City of Portland
Development Review Application
Planning Division Transmittal form

PROJECT NAME: Baxter Boulevard North Storage Conduit

Project Name: **Baxter Boulevard and Back Cove Trail Improvements and Structures associated with City of Portland CSO Project**
Project ID: 2012-587
Address: North Baxter Boulevard and southeast corner Payson Park
CBL: 159-G-1
Applicant: City of Portland Department of Public Services
Planner: Jean Fraser

TO: Jean Fraser, Planner
FROM: David Senus, P.E. & Ashley Auger, E.I.T.
DATE: November 7, 2012
RE: Level I Site Plan Application – Baxter Blvd Storage Conduit Utility Building and Trail Work

SHEET # 11 **OF** #PGS

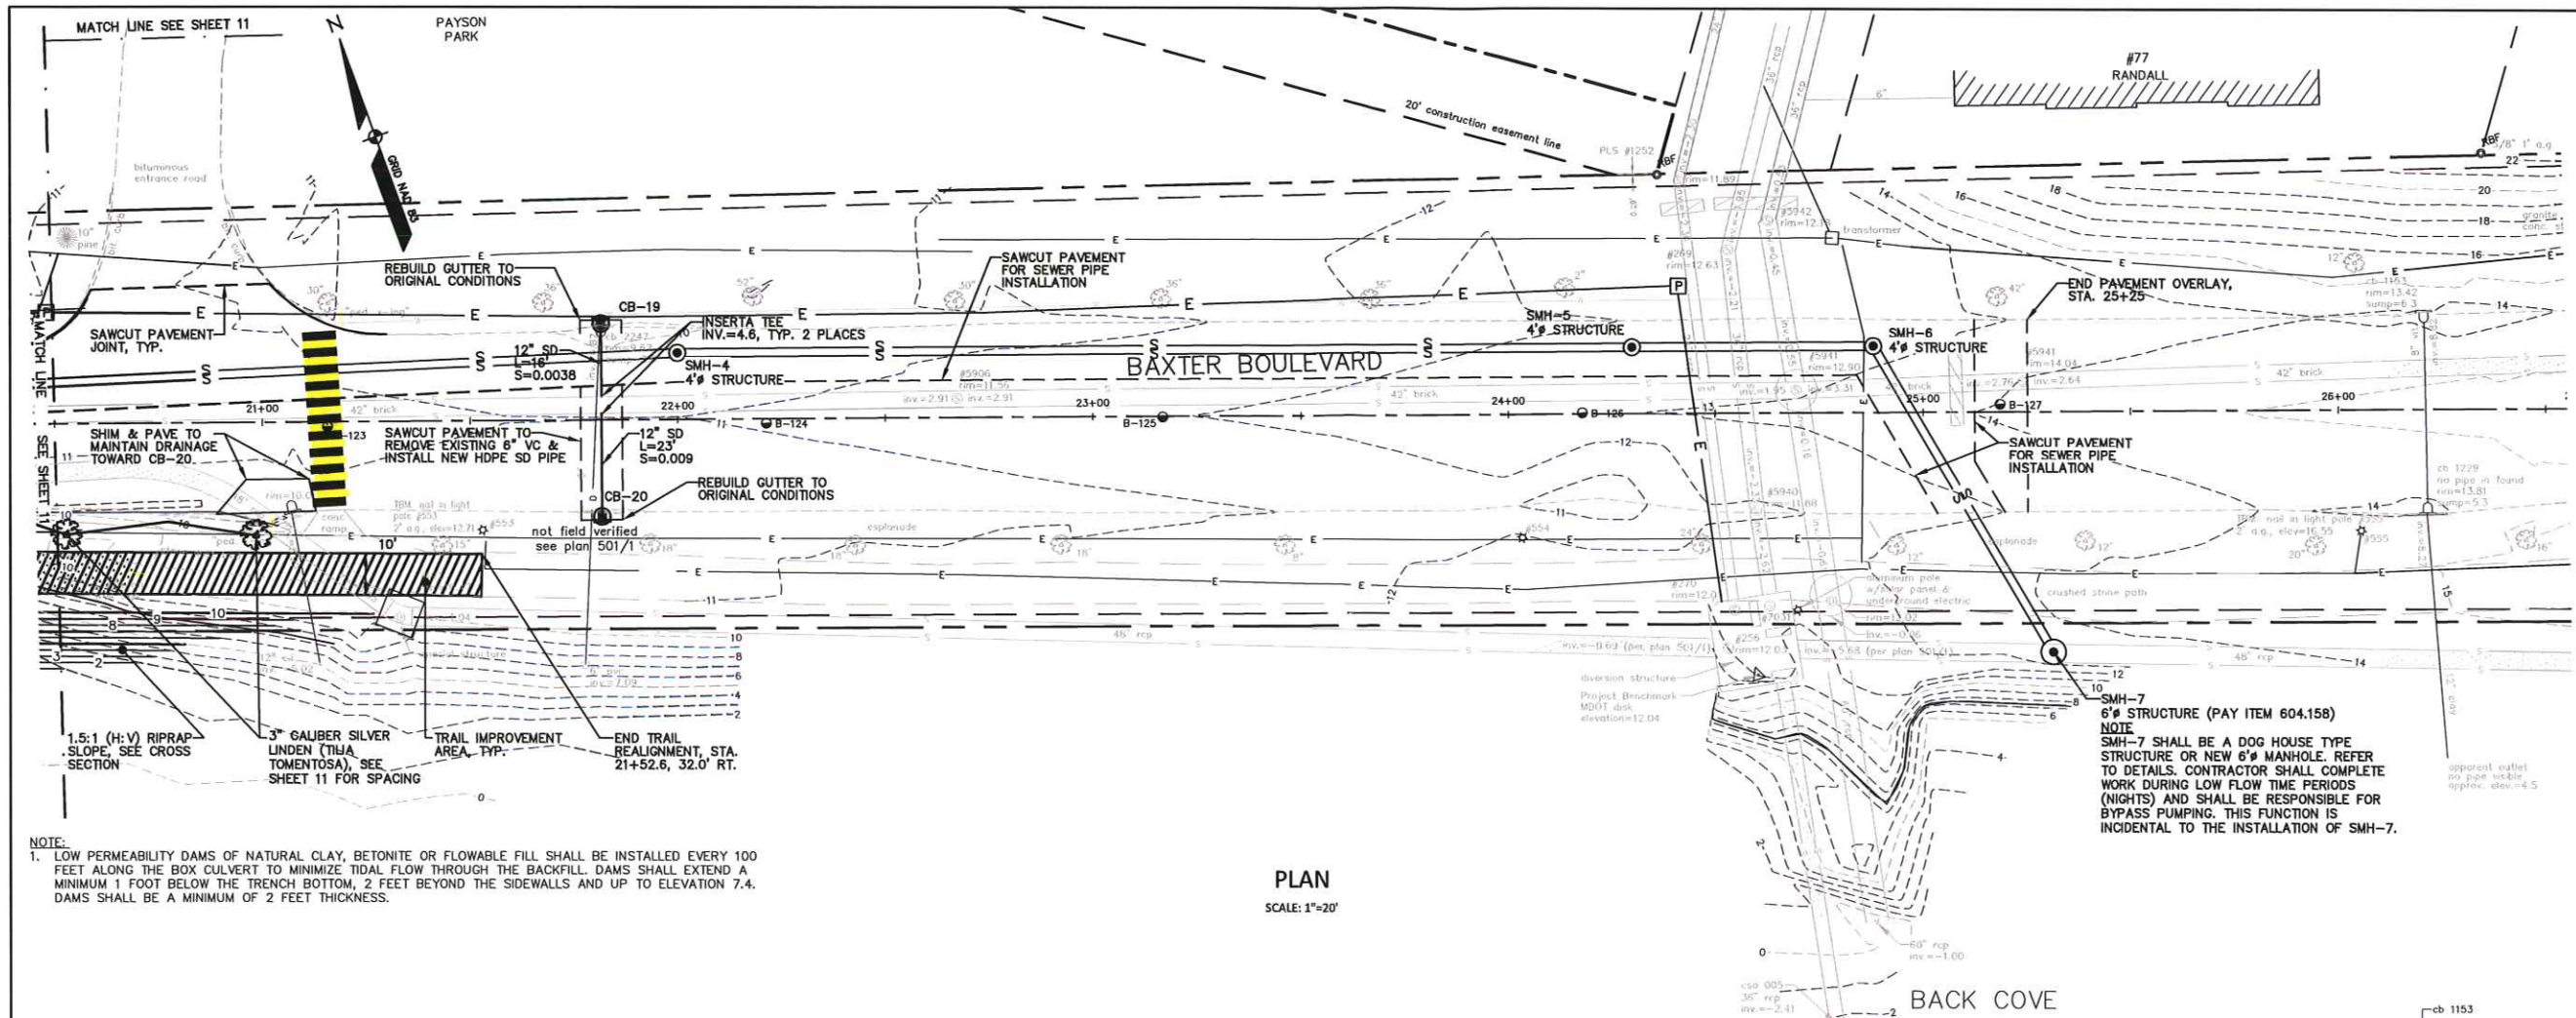
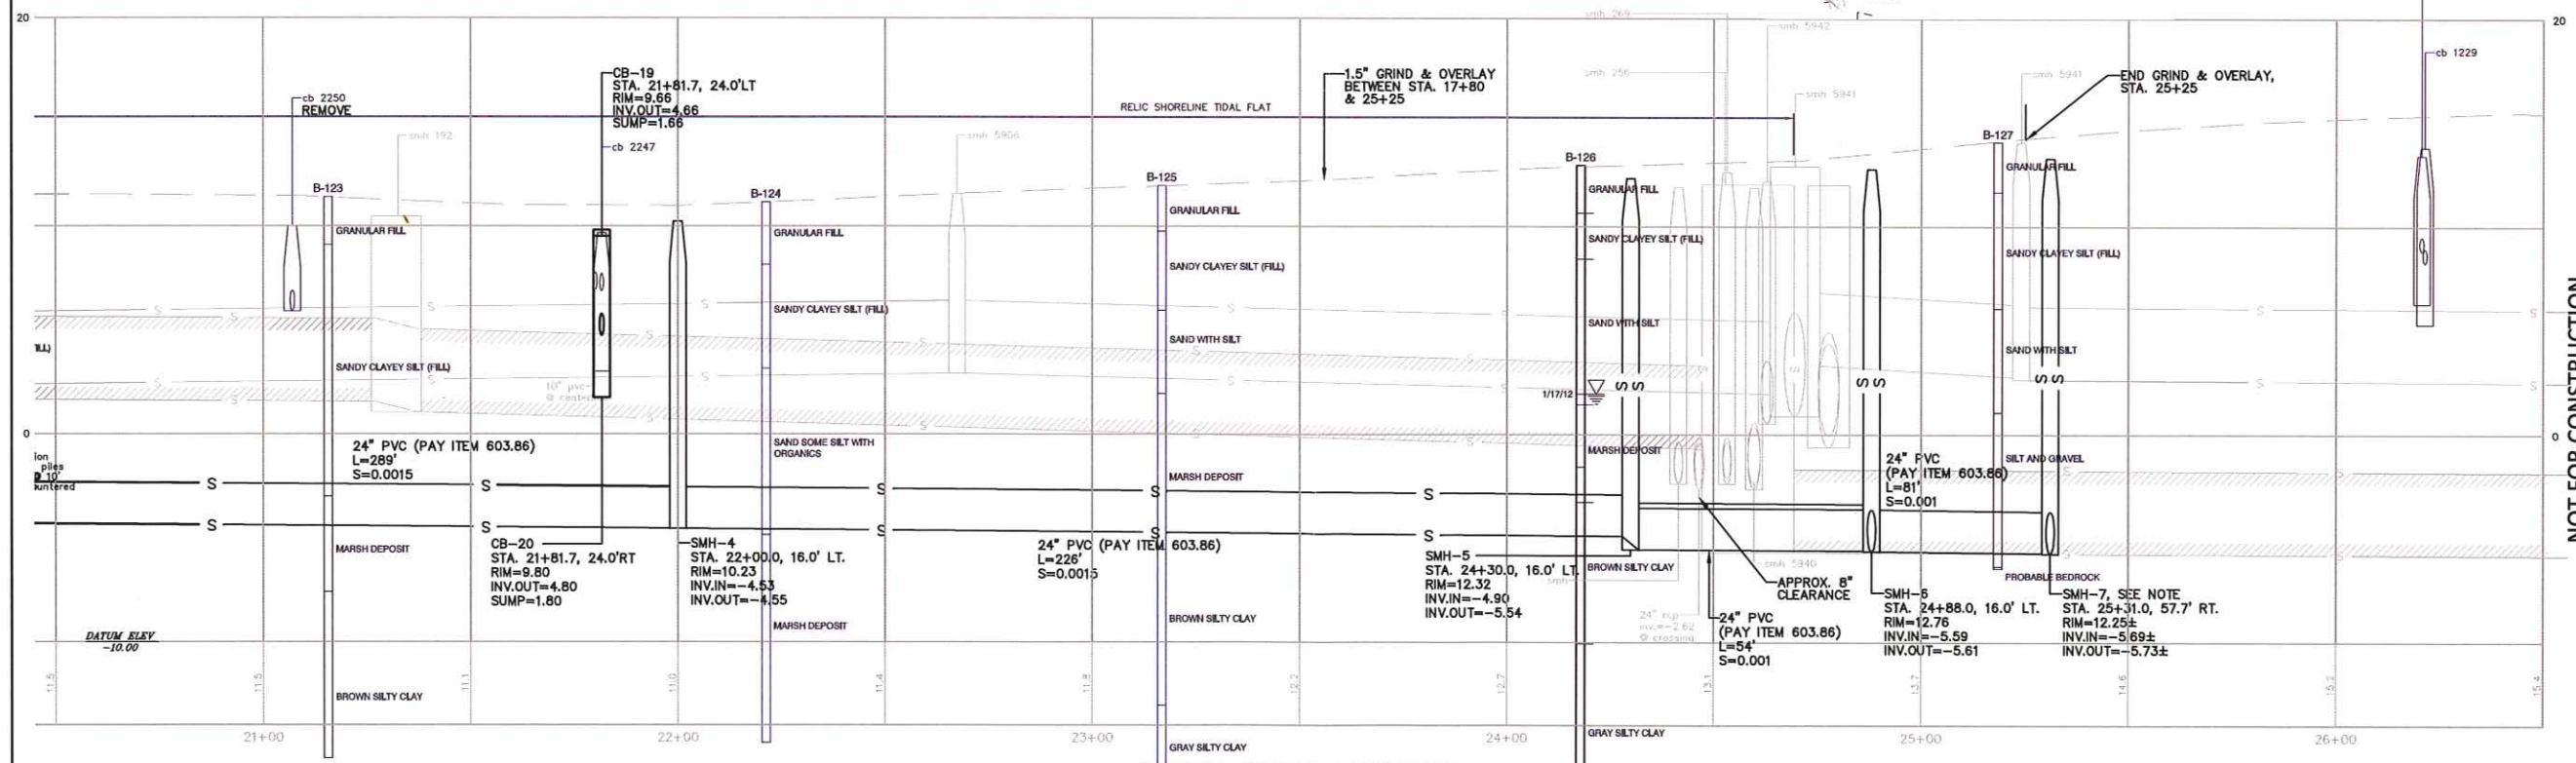
We also need the latest revised plans (Sheets 11 and 12 dated Oct 1, 2012) as referred to in the NRPA permit and it would be good for us to have the application as sent to MDEP plus a copy of the Army Corps Permit (but not the PBR permits). I will expedite the Site Plan Review once I receive the Landscape/Vegetation plans and revised Sheets 11 and 12.

3. Sheet 11 also has the parking lot information. Deb and the Historic Preservation board have not yet made a decision on the material of the parking lot. I will be bidding it as paved. The lot will remain the exact same size and we will replace the granite at the back edge as it currently exists. I have added to catch basins to the street to help with the existing drainage issues.

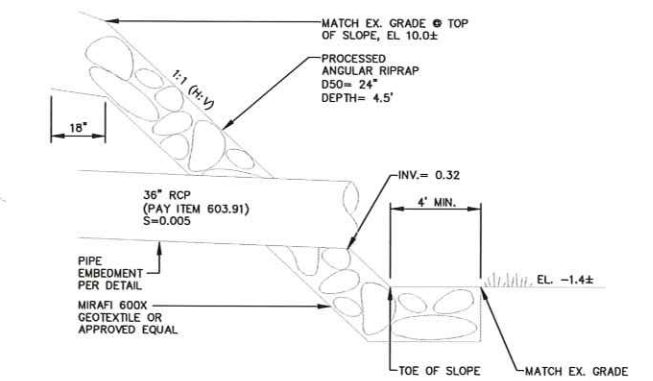
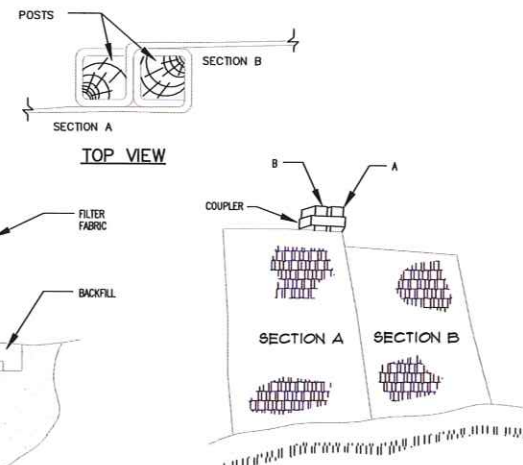
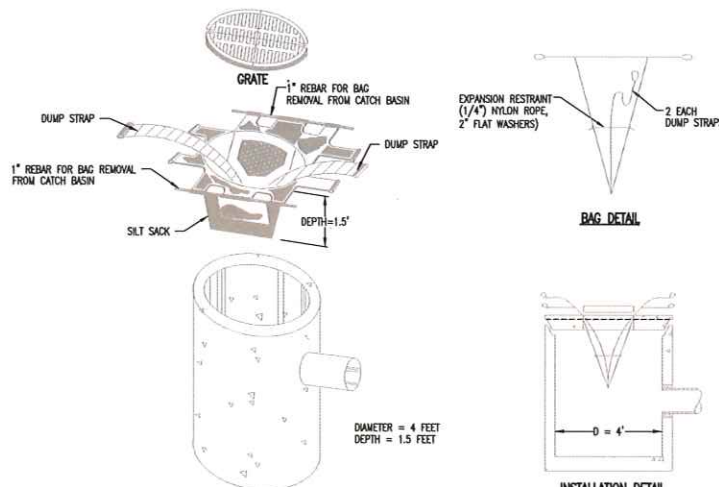
- 1) The Applicant should provide additional information on the installation and/or replacement of slope stabilization riprap, including stone size, and thickness.

- 2) The Applicant should provide design details for the work (trail section, slope stabilization details, erosion control details).
- 3) A Level I Site Plan Submission is required to include proposed stormwater management controls and a soil erosion control plan (*City of Portland Land Use Code, Article V. Site Plan, Section 14-527(b) (12) and (13)*). Level 1 Site Alteration Plans are required to conform with certain site plan standards contained in the City Code of Ordinances, (*City of Portland Land Use Code, Article V. Site Plan, Section 14-526(b)3. – b,c,d*) specifically conformance with the Basic, General, Flooding, and Urban Impaired Stream standards

24 inch riprap with a thickness of 4.5 feet is specified. Please refer to enclosed Sheet 26 for details and construction notes.

Sheet 27 (enclosed) shows a typical trail section. Riprap slope stabilization details and construction notes, erosion control details for stabilized construction entrance, silt sack, silt fence and erosion control blanket installation, are all shown on Sheet 26. In addition, we have enclosed an Overall Design Plan that shows the riprap slope and CSO control station in relationship to the entire project for reducing Combined Sewer Overflows ("CSO's"). Please note the riprap slope is shown as "trail improvements" on the Overall Design Plan.
